D206-642-241
Job Sheet 191322

Part Name: Replacement Skidtube, High Gear with Standard Wearplates Fits LH or RH

DRAWING NO. D2650	TITLE 206/407 SKIDTUBE ASSEMBLIES	REV. F	DART AEROSPACE LTD ENGINEERING ORDER		D.E.O. NO. D2650-F-1	SHEET NO. SHEET 1 OF 1	SCALE NTS
DRAWN <i>[Signature]</i>	CHECKED A.P.	MFG. APPR. <i>[Signature]</i>	APPROVED <i>[Signature]</i>		DE APPR. <i>[Signature]</i>		
DATE 12.10.12	DATE 12.10.22	DATE 12.10.22	DATE 12.10.22		DATE 12.10.22

CHANGE C'BORED WELDED CROSSBOLT SPACERS TO SWAGED SPACERS

DETAIL G

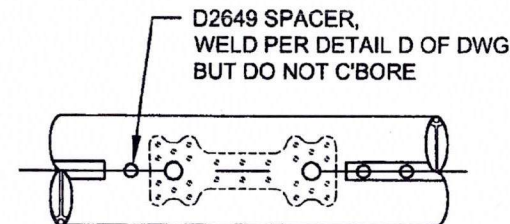
ADD DETAIL G BELOW, WHICH IS THE SAME SECTION VIEW AS DETAIL D OF DWG.

AFTER DRILLING AND BENDING ASSEMBLY
PERFORM THE FOLLOWING FOR Ø0.375 HOLES THAT ARE
CURRENTLY C'BORED:

1. INSERT D4720-1 SPACER, 16 PL (-1) OR 17 PL (-3)
OR 19 PL (-5) OR 23 PL (-7)
2. SWAGE TO Ø0.313 X 0.75 DP PER QSI 002
3. TRIM / GRIND FLUSH PER QSI 002

AMENDMENT TO DETAIL B
NOT TO SCALE

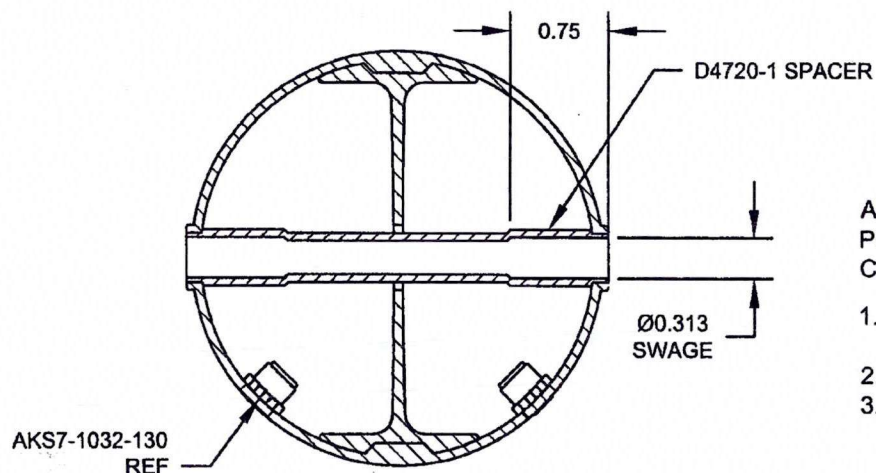
C'BORED HOLES ARE NOW SWAGED PER DETAIL G BELOW. FOR THE Ø0.375 HOLE THAT IS NOT C'BORED, WELD PER DETAIL D OF DWG (SEE AMENDED DETAIL B FOR REFERENCE).
